ADDENDUM

Addendum Number One (01)
TO PLANS AND SPECIFICATIONS FOR
Alvin ISD Elementary School #23
STANTEC Project Nos.: 214001269

September 8, 2025

1 LEVEL 1 - UNDERSLAB PLUMBING PLAN - AREA A
1/8" = 1'-0"

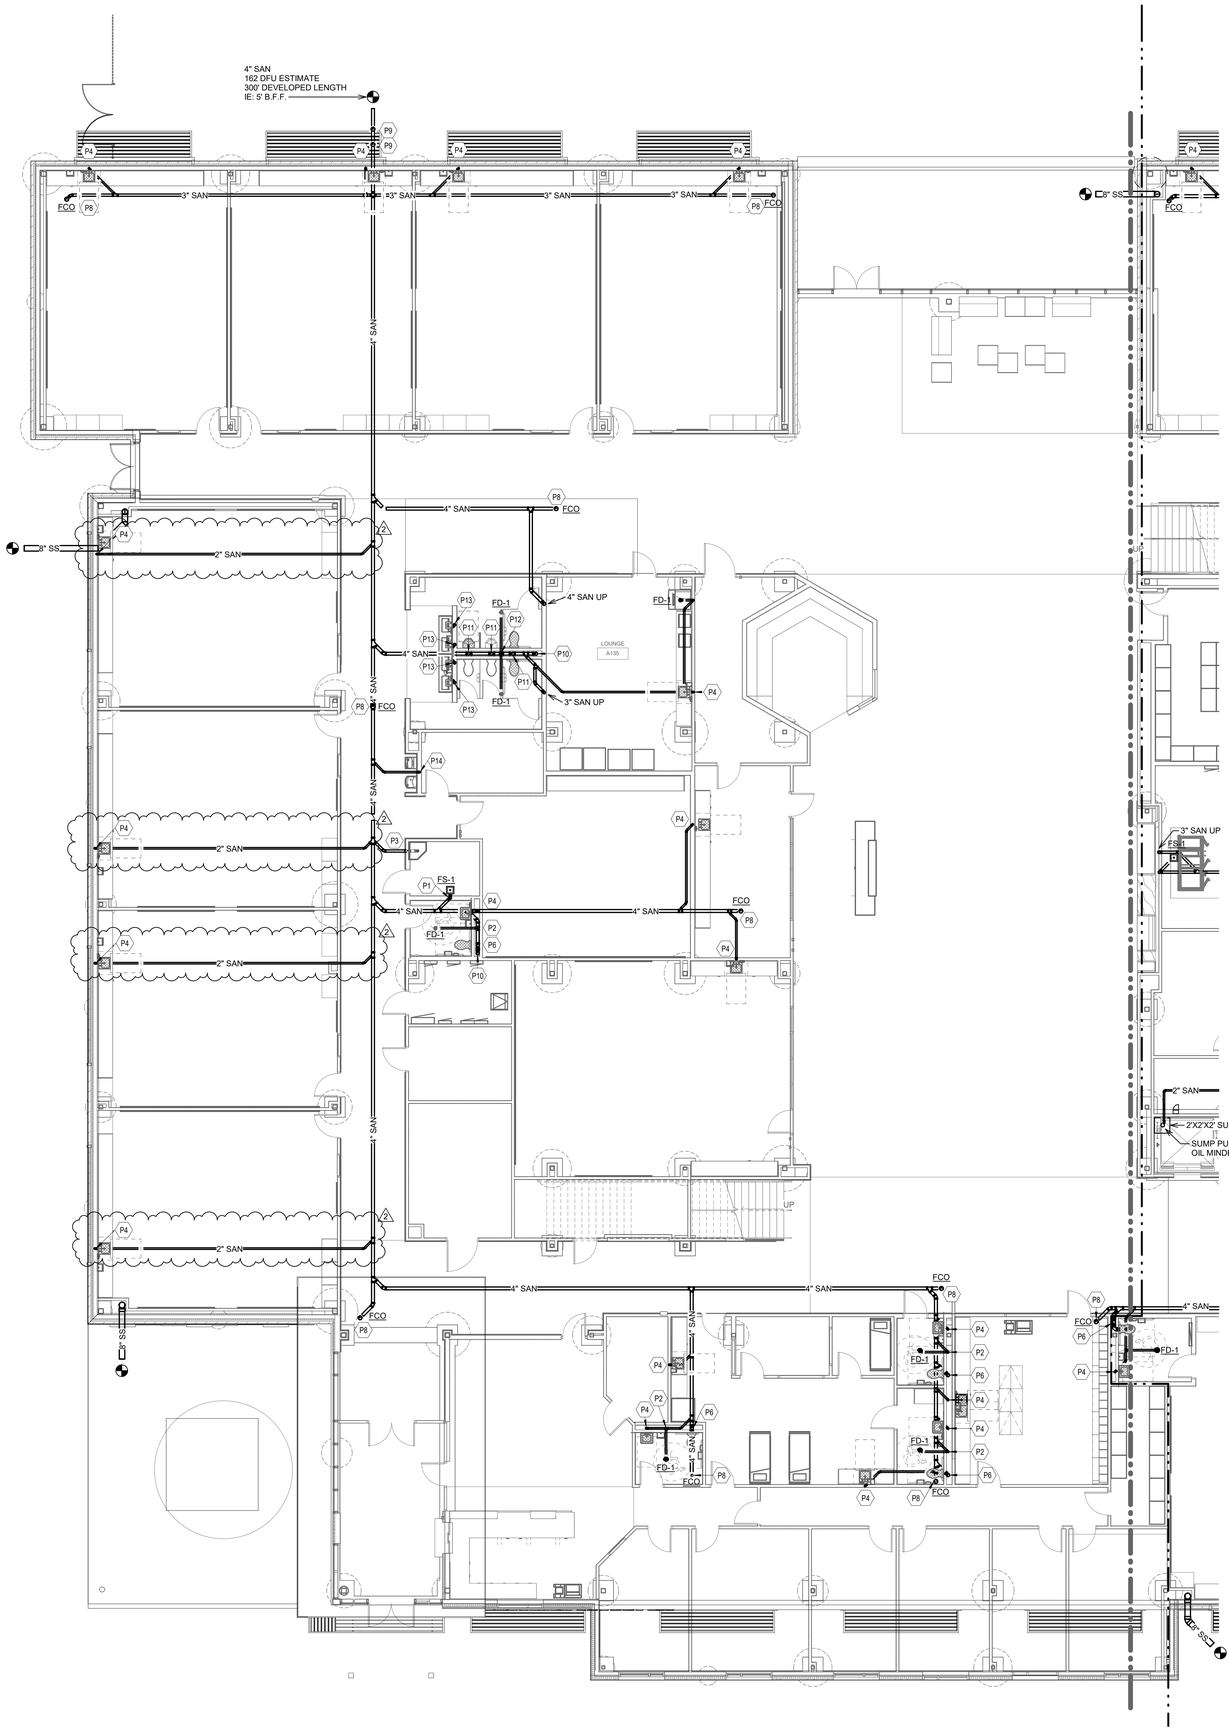
1. Sheet P002 – PLUMBING SITE PLAN
   - Revised storm points of connection.
   - Revised sanitary POC callouts.
2. Sheet P101 – LEVEL 1 - UNDERSLAB PLUMBING PLAN - AREA A
   - Sink locations revised.
3. Sheet P211 – LEVEL 1 - PLUMBING PLAN - AREA A
   - Added Mech room floor sinks.
   - Added hot water balancing valve tags.
4. Sheet P212 – LEVEL 1 - PLUMBING PLAN - AREA B
   - Added hot water balancing valve tags.
5. Sheet P214 – LEVEL 1 - PLUMBING PLAN - AREA D
   - Revised to pick up new sink.
6. Sheet P221 – LEVEL 2 - PLUMBING PLAN - AREA A
   - Added Mech room floor sinks.
7. Sheet P222 – LEVEL 2 - PLUMBING PLAN - AREA B
   - Added Mech room floor sinks.
   - Removed classroom sinks.
8. Sheet P223 – LEVEL 2 - PLUMBING PLAN - AREA C
   - Revised to pick up new sink.
9. Sheet P303 – PLUMBING ENLARGED PLANS
   - Revised sanitary.
10. Sheet P401 – PLUMBING DETAILS
    - Revised detail.
